**IEEE P802.15
Wireless Personal Area Networks**

Project	IEEE P802.15 Working Group for Wireless Personal Area Networks (WPANs)
Title	NBA UWB MMS MSC and Description
Date Submitted	23 August 2024
Source	Billy Verso (Qorvo), billy.verso at qorvo.com
Re:	IEEE P802.15.4ab
Abstract	Comment Resolutions for selected comments on the LB207 / P802.15.4ab D01.
Purpose	This document provides text changes intended to be part of the final IEEE Std 802.15.4ab (amendment to IEEE Std 802.15.4), as part of resolving selected comments from the consolidated spreadsheet (doc 15-24-0371) that have been assigned to the author to resolve.
Notice	This document does not represent the agreed views of the IEEE 802.15 Working Group or IEEE 802.15.4ab Task Group. It represents only the views of the participants listed in the "Source(s)" field above. It is offered as a basis for discussion and is not binding on the contributing individual(s) or organization(s). The material in this document is subject to change in form and content after further study. The contributor(s) reserve(s) the right to add, amend or withdraw material contained herein.

10.38.X Control of UWB MMS Ranging

Figure A—Message sequence chart for a one-to-one NBA UWB MMS ranging exchange

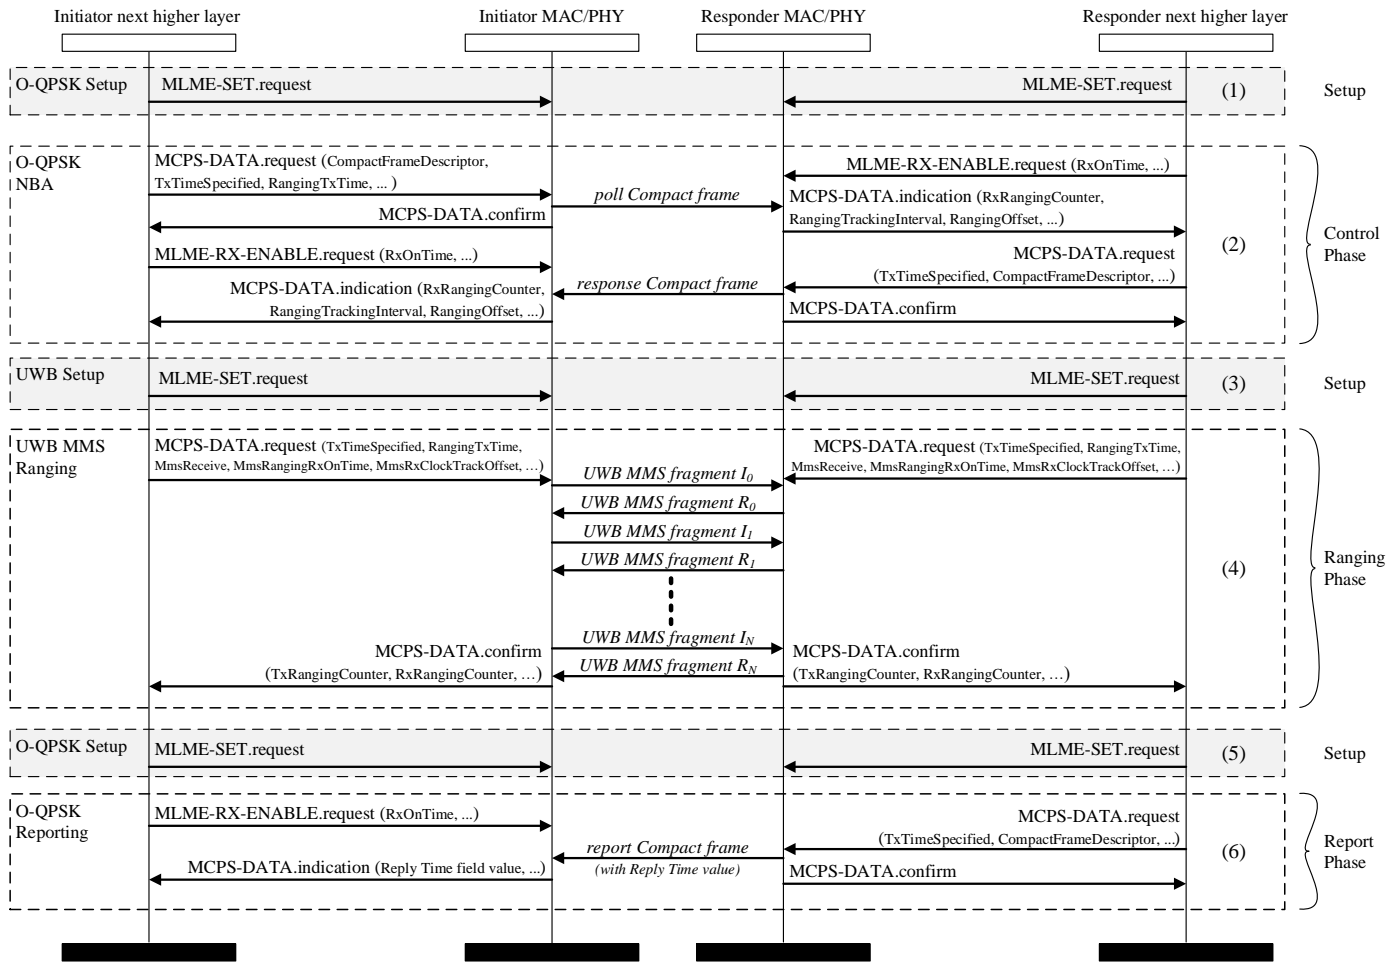
The proposed resolution for this comment, index #1118, is “Revised”, with the resolution being to insert the text & figure from the subsequent pages of this submission into the draft. The proposed “suitable place” for this is after clause 10.38.8, as a new 10.38.9 (with the existing 10.38.9 and subsequent clauses renumbered accordingly).

Insert the following as a new 10.38.9 (with the D01 existing 10.38.9 and subsequent clauses renumbered accordingly):

Figure A presents a message sequence chart for the case of two HRP-ARDEV devices engaging in an NBA UWB MMS ranging exchange. This shows the interactions between the next higher layer and the MAC/PHY in each device, and between the two devices, (initiator and responder), over the air-interface. The roles of initiator and responder, and the starting time, are assumed to have been predetermined. This typically would be via a Start of Ranging Compact frame sent by the initiator and received by the responder as part of the initialization and setup, (described in 10.38.3), which is the assumption in the description below, but it might also be achieved via some OOB means. The details of the figure and the various interactions it shows are described in the paragraphs below.

Figure A shows the three phases of the NBA UWB MMS ranging exchange, i.e., control phase, ranging phase, and reporting phase, with the interactions in each of these phases encompassed in a (numbered) dashed rectangle to distinguish the phase and the PHY being employed. That is, the NBA control phase utilizing the O-QPSK PHY, the ranging phase using the HRP UWB PHY, and the reporting phase again using the O-QPSK PHY.

Before each phase of the MMS ranging exchange shown in Figure A, there is a numbered dashed rectangle with the designation “setup” to indicate that the next higher layer needs to make the appropriate configuration changes for the upcoming phase. In each case this setup is shown as a single MLME-SET.request, which is the primitive used to set PIB attributes. In practice, several items may need to be configured, in which case more than one primitive invocation will be needed, but this depends on what happened last. For instance, if this is the second of a series of ranging exchanges, then for the setup labelled (1) in the figure the O-QPSK PHY may already be appropriately set up, (e.g., from the previous reporting phase), with no reconfiguration needed except perhaps to change the channel if channel switching is being employed.

With reference to Figure A, after the appropriate O-QPSK PHY configuration, in the dashed rectangle labelled (1), to complete the control phase, in dashed rectangle labelled (2), firstly the NBA poll Compact frame is sent/received, as follows:

Now initiator and responder devices transition to the ranging phase applying the appropriate UWB setup as part of this transition as illustrated in Figure A by the dashed rectangle labelled (3). While several items may need to be configured, at the very least the next higher layer on both devices will issue an MLME-SET.request to set the phyCurrentChannelInfo to select the UWB PHY, i.e., so that the next MCPS-DATA.request is launching a UWB packet instead of an O-QPSK packet. Other parameters defining the UWB MMS packet, (e.g., phyUwbMmsRsfNumberFrgs, etc.), may also need to be configured if the initiator’s poll included a Ranging PHY Configuration field specifying new values.

Now, the initiator and responder devices transition to the reporting phase applying the appropriate O-QPSK setup as illustrated in Figure A by dashed rectangle labelled (5). While several items may need to be configured, at the very least the next higher layer on both devices will issue an MLME-SET.request to set the *phyCurrentChannelInfo* to select the O-QPSK PHY.

While reports could be sent in either or both directions, for the purposes of illustrating this phase, a single report from the responder to the initiator is shown in Figure A and described here. This report conveys the reply time, T_{reply} . With reference to Figure A, after the O-QPSK PHY configuration (5), the NB report from the responder is sent/received as follows:
